SERVICE BULLETIN

NUMBER: 15-236-18R

REVISED: 02/19/20

SUBJECT: Reprogramming File Availability for Optimization of Harman Gen 3.1 Audio and Navigation Head Units

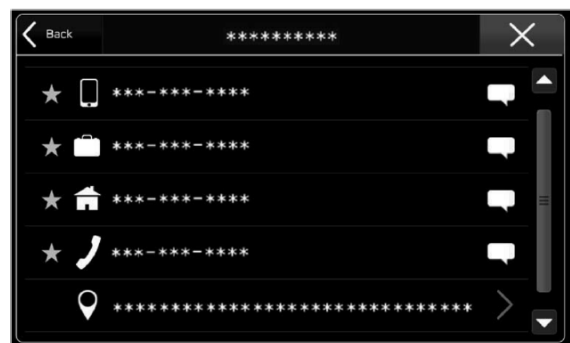
NOTE 2: To meet with customer expectations, Ver. 6 software will increase the Hands-Free conversation volume by 6dB against the base audio volume. Customers will now be able to hear Hands Free conversation volume which used to be at audio volume level 30 at level 22 after installing this update. If the customer prefers the original Hands-Free conversation volume setting, it can be manually adjusted by following: Home >> Settings >> Sound Tab >> Phone Volume >> then lowering the volume 6 - 8 steps.

The base audio volume setting chosen at the Factory Data Reset is at level 22 compared to the previous setting, which is level 30. (This means customers will no longer have to adjust the base audio volume to get comfortable Hands-Free conversation volume.)

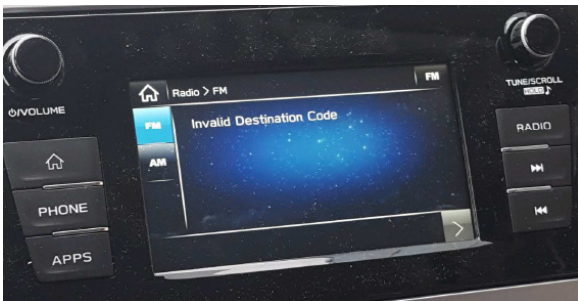
3) <Scan> previously displayed on SXM screen was changed to <Tune Scan> (a.k.a. SEEK).
